With reference to his application dated 3rd inst. with plans for plot No. 50, A-20 Napier Quarter Mr: Bassamal Kakoomal is informed that the external walls must be packed. Open space must be shown for ventilating the shops. The plan and Section do not agree. They are incorrectly drawn.

NOTICE UNDER SECTION 96 OF ACT III OF 1901.

a house on plot No. 50
Survey Sheet No. A-20 situate in Hajee Abdoda
Street, Napier Quarter.

ELEVATIONSECTION ON A.BPLAN OF PROPOSED BUILDING
ON PLOT NO 50 SHEET A 20NAPIER QUARTERSCALE 8 FEET TO AN INCHSITE PLANSCALE 20 FT TO AN INCHGROUND FLOOR PLANFIRST FLOOR PLANSECOND FLOOR PLANPanram C. Thadani
ARCHITECT

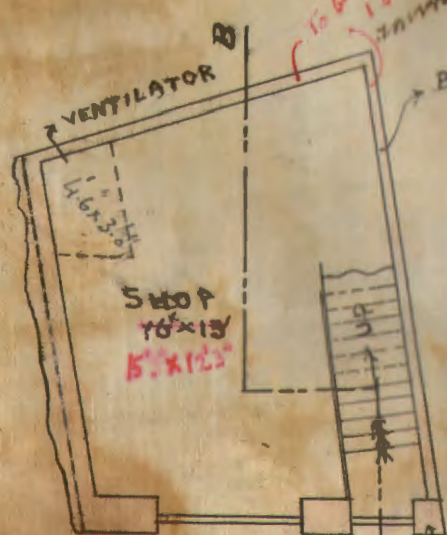
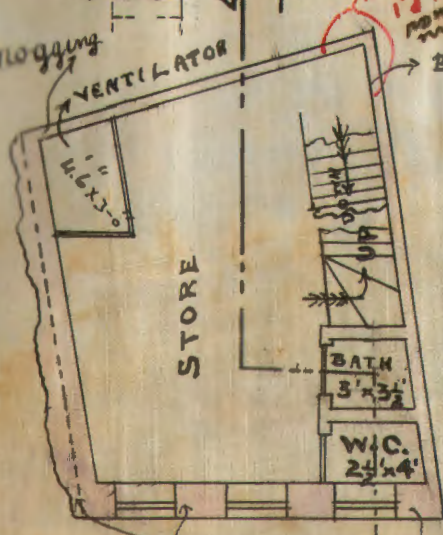
The external walls must be put into
open space must be shown for
ventilating the shop the plan
& section do not agree, they are in-
correctly drawn.

I have made a sketch of
the plan - not
strong enough for a
three storey building.

The internal mud & wood wall marked
thus X is not strong enough to carry a three
storied building, it should be made proper.

I beg to submit herewith
plans of proposed building
on plot no 50, sheet A 20, Naped
mark with 7" walls now shown
as 1-3" walls, and the corrections
signed by me at places shown
in the drawings. You will
now kindly give me permission
to build -

The external walls are ~~plaster~~ packed
i.e. of stone & lime ~~by~~ ^{with} ~~lime~~ ^{lime} ~~mortar~~ ^{mortar} ~~all~~ ^{all} ~~times~~ ^{times} ~~filled~~ ^{filled}
with ~~nothing~~ ^{nothing} - ~~in the~~ ^{in the} ~~interior~~ ^{interior} ~~no~~ ^{no} ~~work~~ ^{work}
by Hajie Abdullah Sheikh & ~~the~~ ^{the} ~~roof~~ ^{roof} ~~work~~ ^{work}

The plan and ~~section are~~ ^{correctly}
drawn - Permission to build may
kindly be accorded early -
